PT 8633/914 SDI Test Pattern Generator

Supplement to: PT 5300 Reference: Manual no. 9499 491 02811

The supplement describes the modifications made to the standard instrument.

Plot of the modified data stored in PROM's

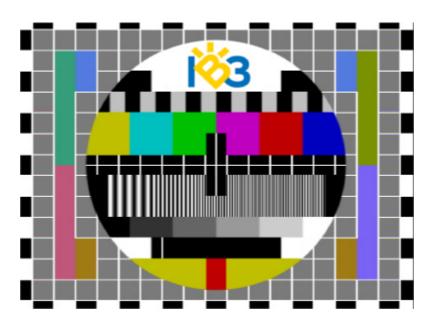
Modification of PT 8633

The Philips pattern, 4:3, 625 lines, has been modified with the logo as described in picture files supplied by IB3, Spain.

The one logo part of the picture have been shaped to give a reasonable video bandwidth. The resolution has been changed to fit the resolution in the generator.

New PROMs installed.

Position:	Code number	Checksum
V69	4008 119 60091	E98E
V86	4008 119 60092	D2F9
V87	4008 119 60093	495F
V88	4008 119 60094	29D3
